# LiDAR Quality Assessment Report

VA-FEMA Region3-Lot2(Washington Co.)  
\_2012

MD\_FEMA-LIDAR-R3Lot2-WashingtonCo...

Lot 2 of 5 lots.

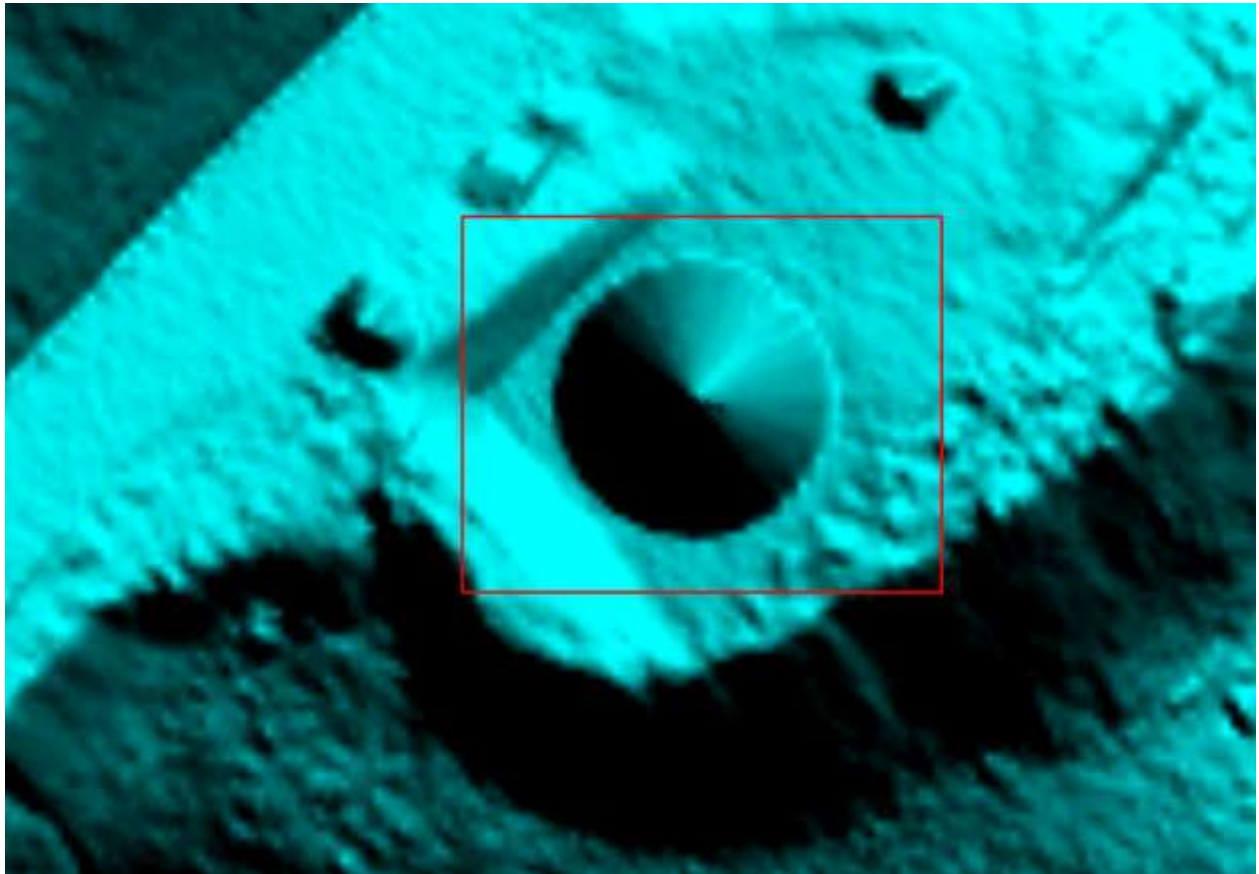
Water elevated above land. Location at  $39^{\circ} 39' 47.2888''$  N,  $77^{\circ} 32' 55.1680''$  W

\*\*Vendor corrected this error 10/23/2012

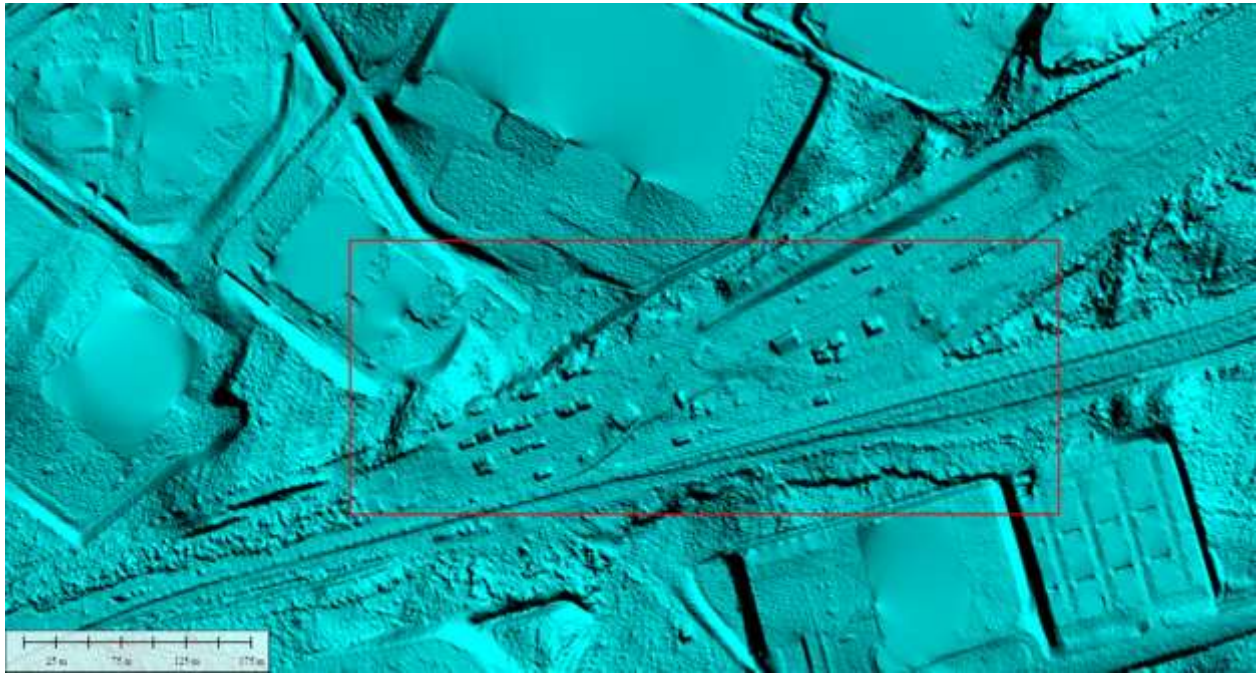
Building in DEM that needs removed. Two occurrences of this error. Location at 39° 41' 51.8623" N, 78° 17' 26.1371" W

\*\*Vendor corrected this error 10/23/2012

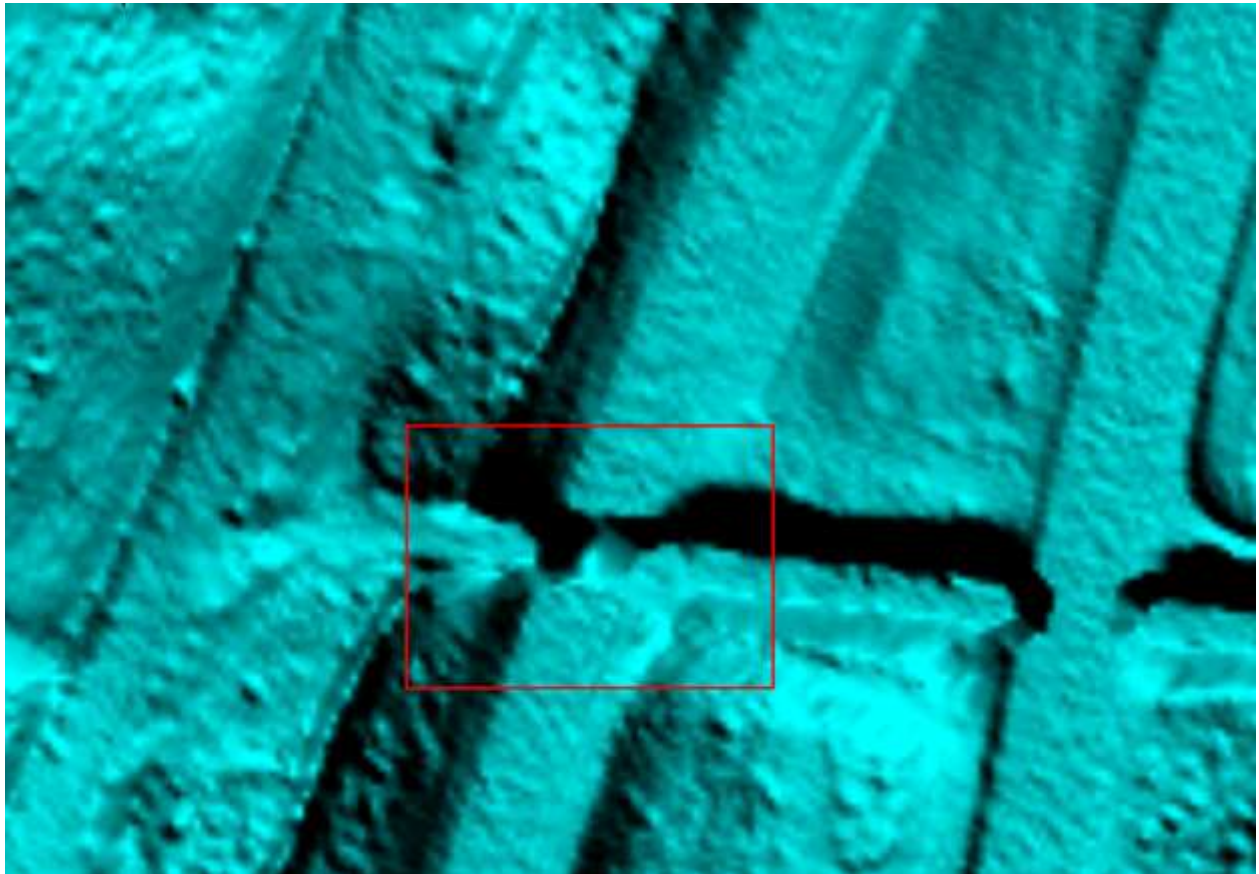
Area to be checked out. Looks like a rail yard with some rail cars/buildings still present in data. Location at 39° 38' 13.3913" N, 77° 45' 24.2113" W

\*\*Vendor corrected this error 10/23/2012

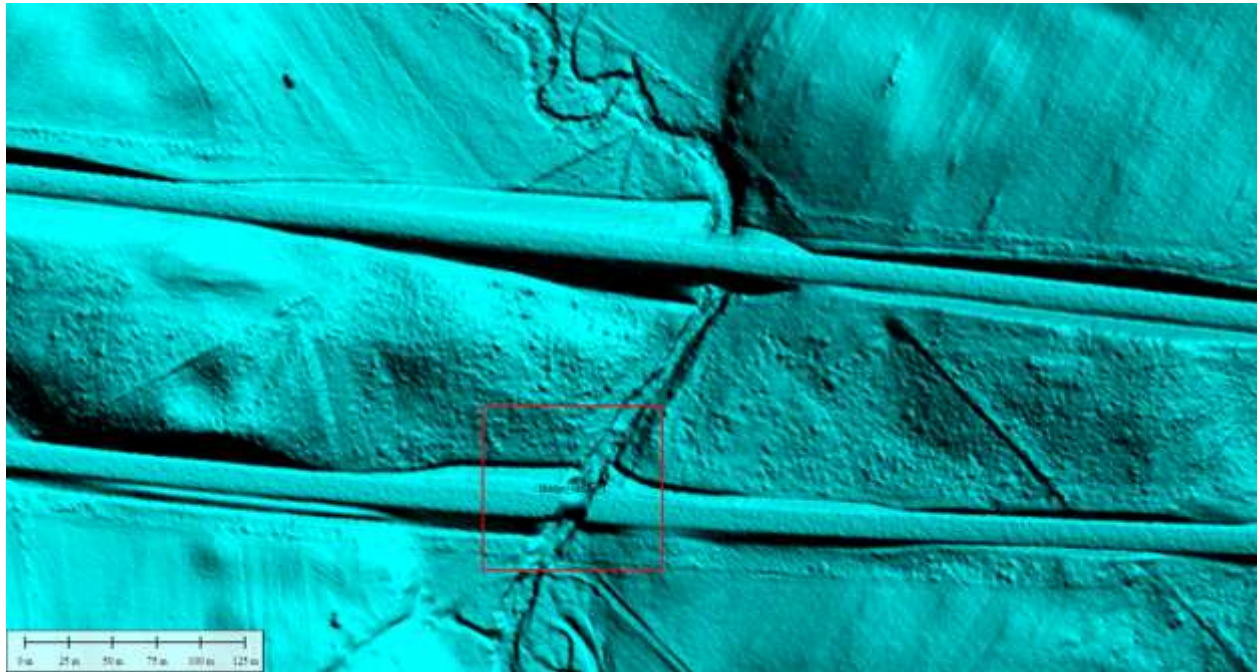
Bridge not completely removed. Location at 39° 43' 2.9845" N, 78° 11' 16.8359" W  
\*\*Vendor corrected this error 10/23/2012
